R20TS0571EJ0101

CS+ Code Generator for RL78,
e² studio Code Generator Plug-in,
Applilet3 Coding Assistance Tool for RL78

1. User option byte (000C1H/010C1H) LVD off setting values

1.3 Details

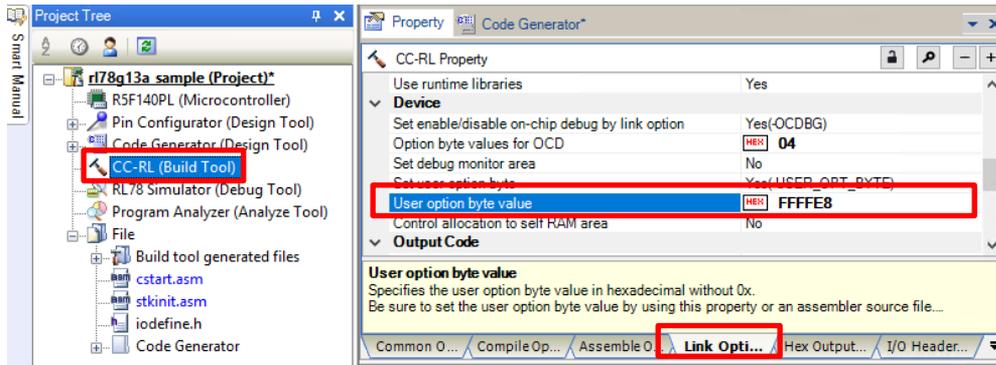
The user option byte (000C1H/010C1H) setting values for LVD off are incorrect.

For details, refer to the technical update of the applicable device.

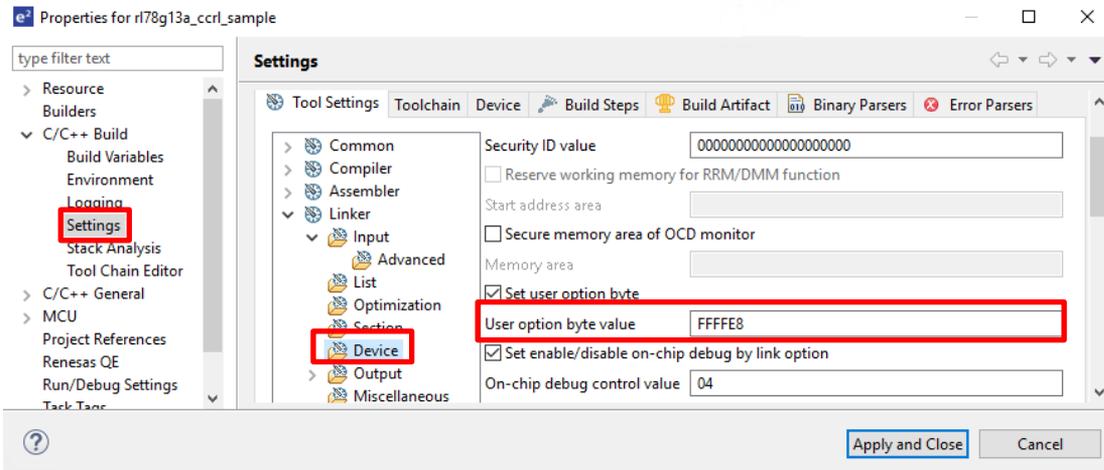
- (2) e² studio

- (2-1) For CCRL
Open the properties. Then, from [Settings] - [Device], change the user option byte value **FFFFE8** to **FF**F3**E8**.
